E4418B-20

S E R V I C E N O T E

Agilent E4418B EPM Power Meter

Hot plugging problem caused by analog switches (U11) under the measurement board assembly (E4418-60007)

Figure 1: No sensor is detected while sensor is connected

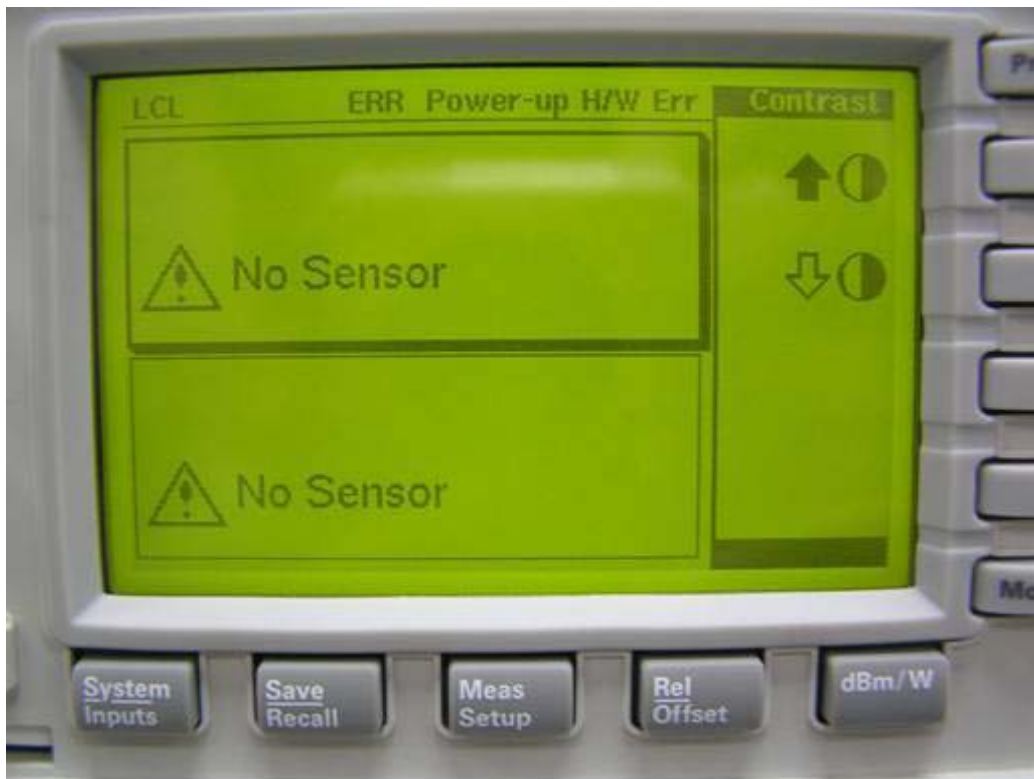
This problem happened on power meter E4418/19B where the power meter will be hang up from time to time and an error message will be displayed. This problem can be duplicated by performing the following steps:

1. Power On the power meter.
2. Connect a power sensor to the power meter.
3. With the power meter still powered, directly unplug the power cord from the power meter.
4. When power cord is plugged back to the power meter, error message will appear in the front display of the power meter as shown in Figure 1.
5. To get the power meter in operation mode again, manually press PRESET button on the power meter's front panel.

It has been found that analog switch (U11) is causing the hot plugging problem. There are 3 different suppliers who are supplying this part: Analog Device, Vishay and Intersil suppliers. The analog switch supplied by Vishay was found to be contributing to the hot plugging problem. It was a batch related issue that happened in 2005. Current parts do not have this failure.

Replace the problematic measurement board with a good measurement board. After replacing the measurement board, repeat the steps mentioned above to verify that the problem is resolved. It should indicate that sensor is connected even after hot plugging.
